# **UT to Rush Fork Stream Mitigation Project Year 1 (2022) Monitoring Report FINAL**

DMS Project ID No. 100068, DEQ Contract No. 7535

Response to DMS Comments (January 6, 2023) for DRAFT Monitoring Year 1 Report.  
UT to Rush Fork Stream Mitigation Project, Haywood County  
French Broad River Basin: 06010106  
DMS Project #100068

Figure 5 Flow Gauge Graphs

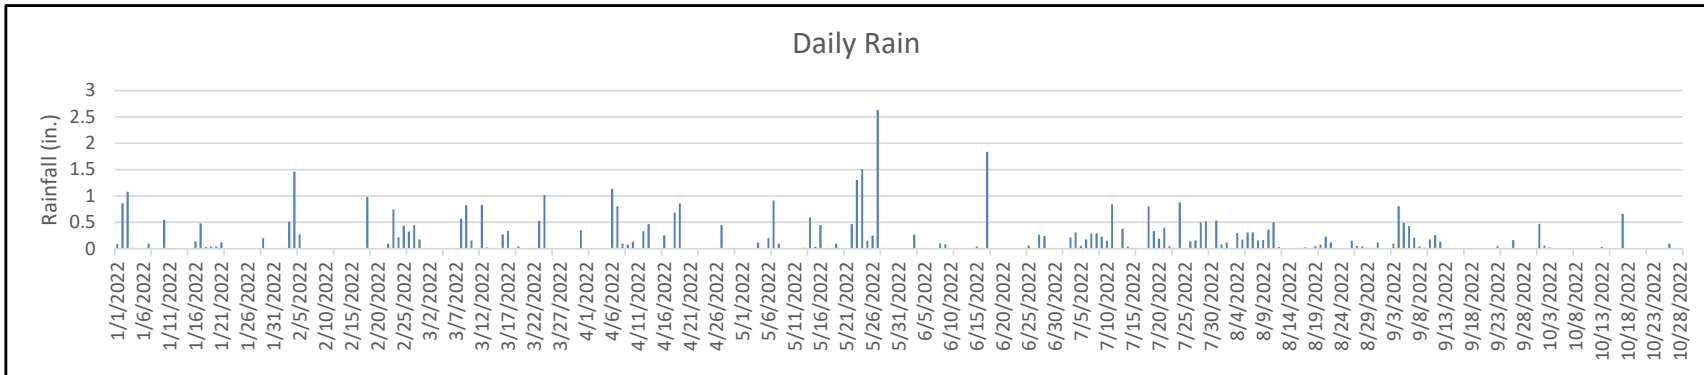
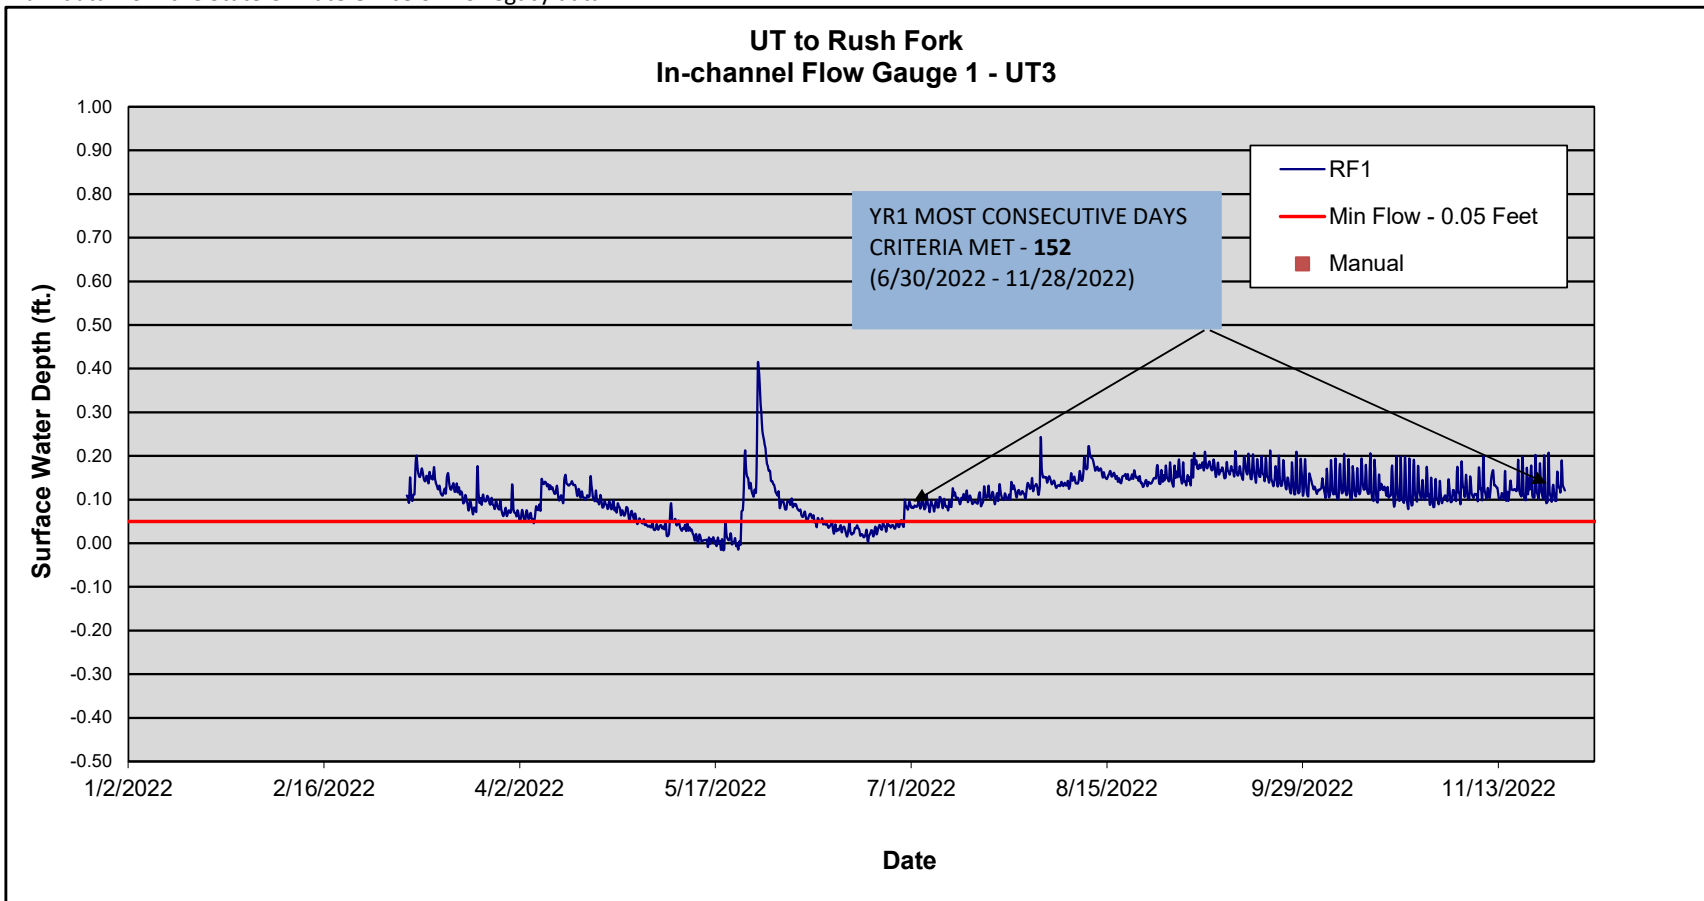
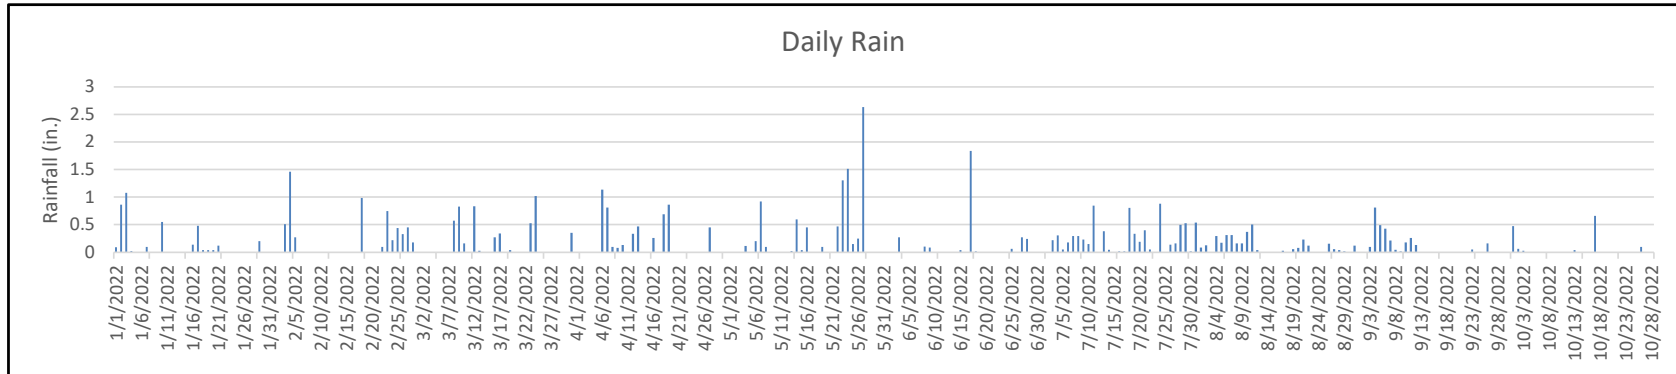
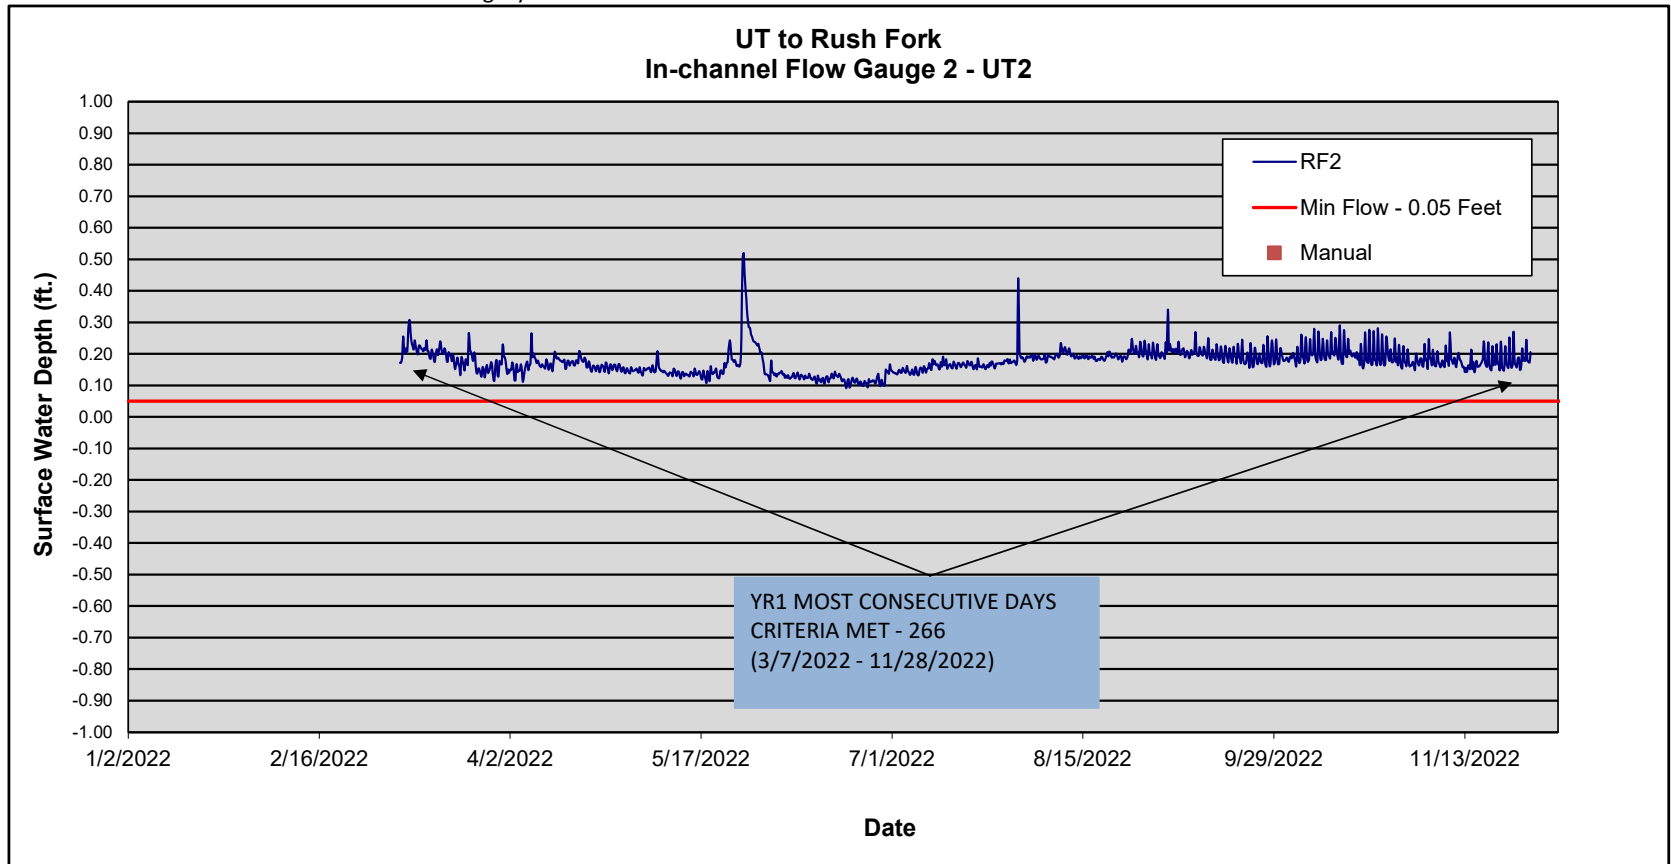
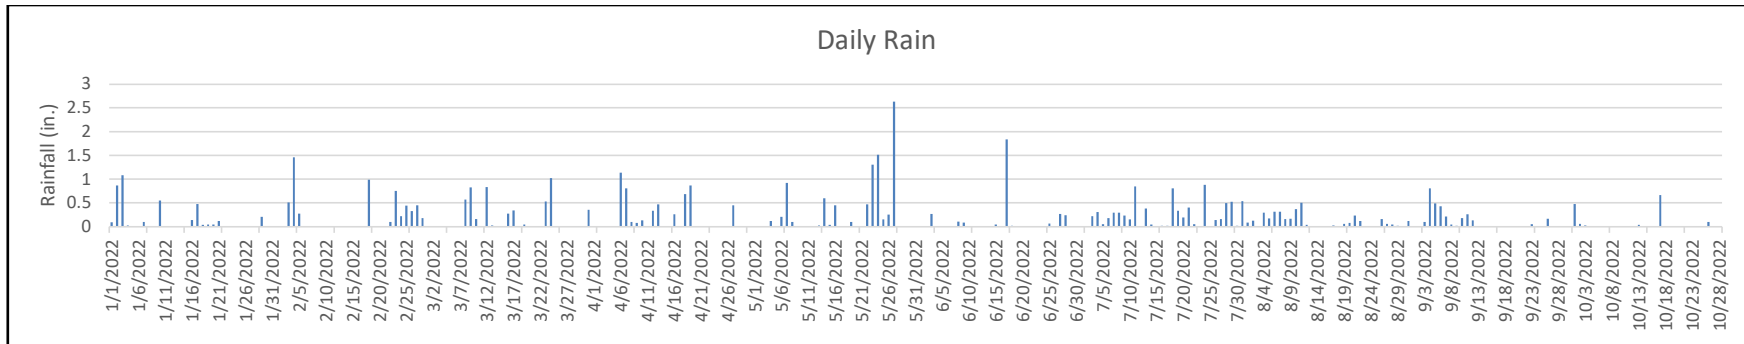
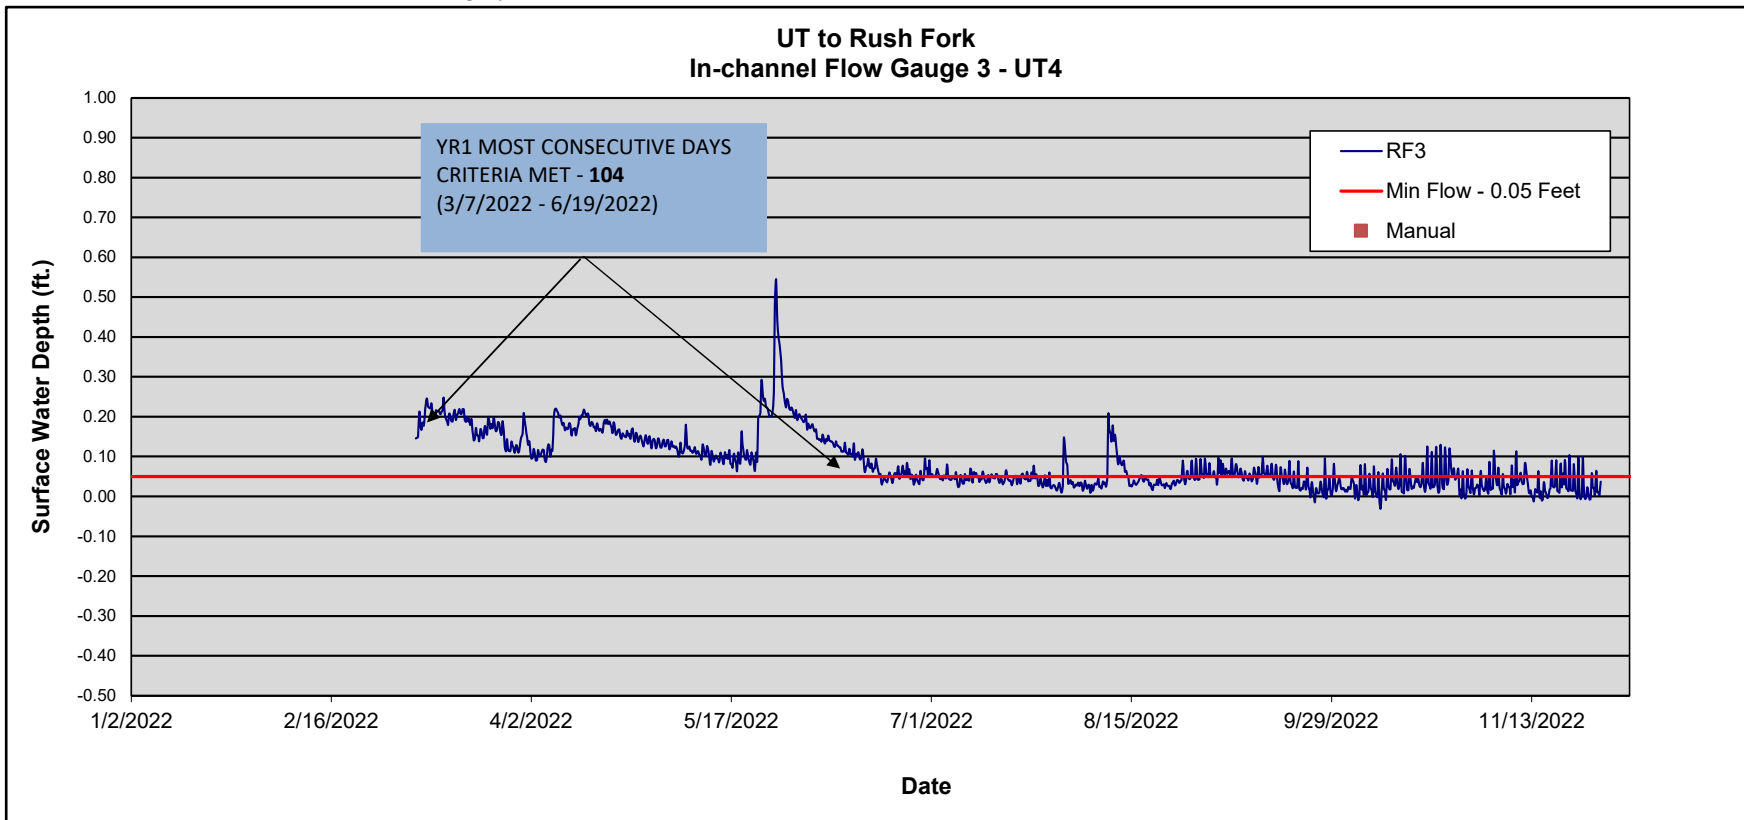
- Table 11: Please review and confirm that the flow gauge data presented in the table and report is accurate. If RF2 was installed in March 2022, how can it have 368 days of cumulative flow? Please update the report as necessary.

**RESPONSE:** This typo was corrected to 266 days of flow and revisions have been made as requested.

Figure 6. Observed Rainfall Versus Historic Averages

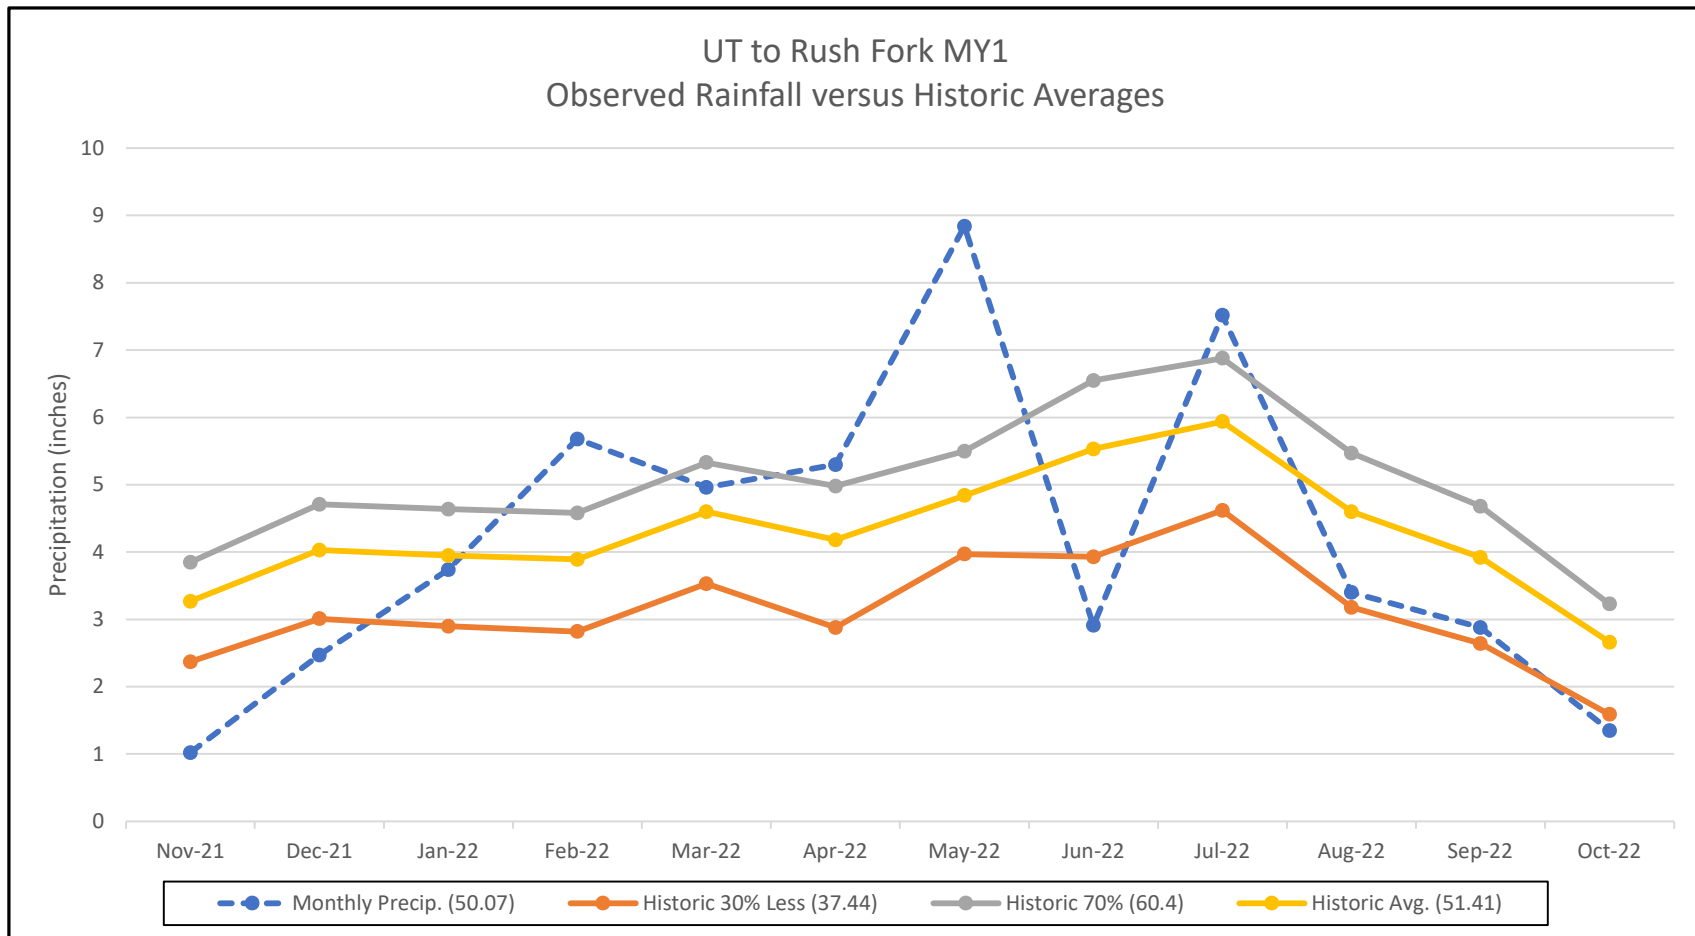
**RESPONSE:** Revision made as requested.
- Section 1.4 Monitoring Results and Project Performance: The report text notes that all observed project rainfall was collected from the North Carolina Climate Office Weather Climate Database Legacy system. In the report text, please also indicate the closest weather station's distance from the project site. Is it close enough to provide accurate rain data or is an on-site rain gauge warranted?

**RESPONSE:** This language has been added to the report as requested. The nearest weather station (WAYN) is located 11.4 miles to the southwest of the project in Waynesville, NC on Test Farm Rd. Data from both the WAYN weather station and data from the Multi-Sensor Precipitation Estimate (MPE) system generated by the North Carolina Climate Office Weather

Station are adequate to characterize precipitation trends at the mitigation site as the MPE system is specific to site coordinates.
